**Comanche Peak Nuclear Power Plant, Units 3 & 4  
COL Application  
Part 2, FSAR**

**2.4.3 Probable Maximum Flood**

CP COL 2.4(1) ~~Replace the content~~Add the following at the end of DCD Subsection 2.4.3 ~~with the following.~~ | RCOL2\_02.0  
4-1

Figure 2.4.3-218 Discharge-Elevation Rating Curve

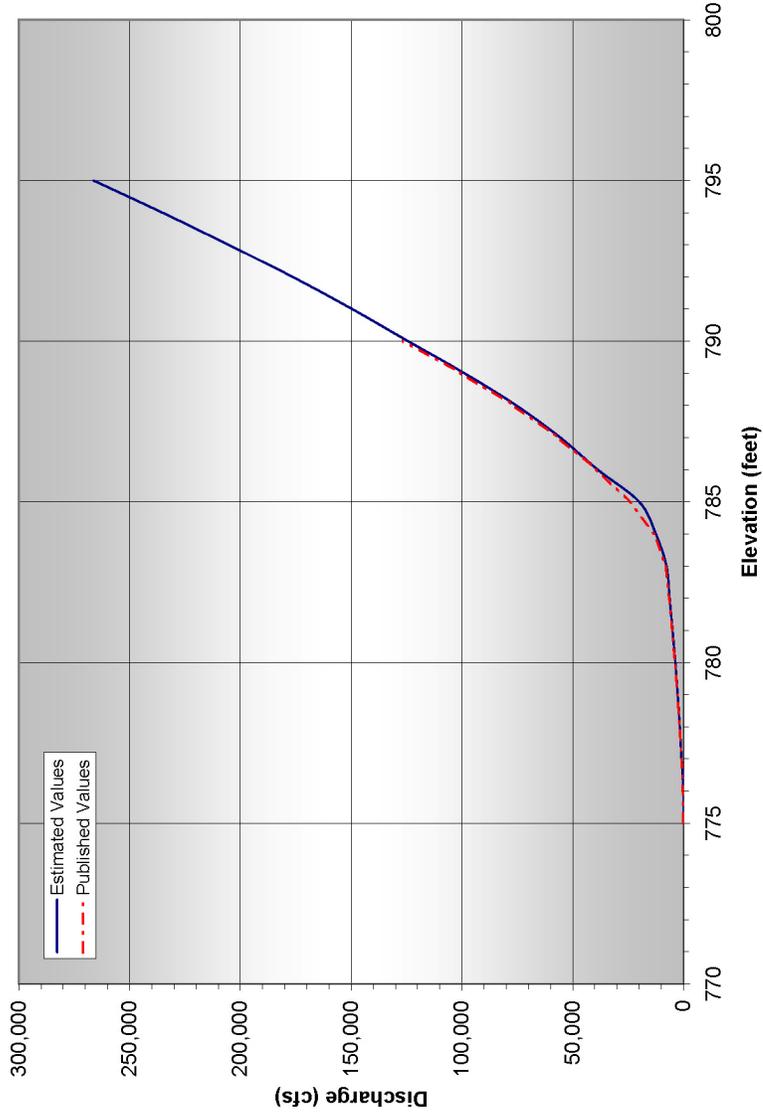
In order to project flows beyond those provided in the Operation and Maintenance Procedures for Squaw Creek Dam, the spillway rating curves have been reconstituted using the methods of the U.S. Bureau of Reclamation Design of Small Dams for the service spillway with an ogee crest and the methods of the Federal Highway Administration Hydraulic Design Series Number 5 for the emergency spillway. It is assumed that the ogee crest is submerged 1 ft by tailwater flooding up to elevation 776 ft. The ogee crest discharge coefficient was determined to range from 0 to 3.71 for an overtopping depth of 1 ft to 20 ft. Submergence effects cease as the depth of overtopping flow approaches 4 ft.

Although the emergency spillway crest is not affected by tailwater, submergence is accounted for based on the effects of flow in the channel immediately downstream from the spillway. The rating curve in the Operation and Maintenance Procedures accounts for downstream channel depth of flow from 100 percent to 90 percent of the overtopping headwater depth. Based on the effects of downstream flow, discharge coefficients were derived to range from 1.46 to 2.55 for an overtopping depth of 1 ft to 12 ft.

The combined service spillway and emergency spillway rating curve is provided in Figure 2.4.3-218.
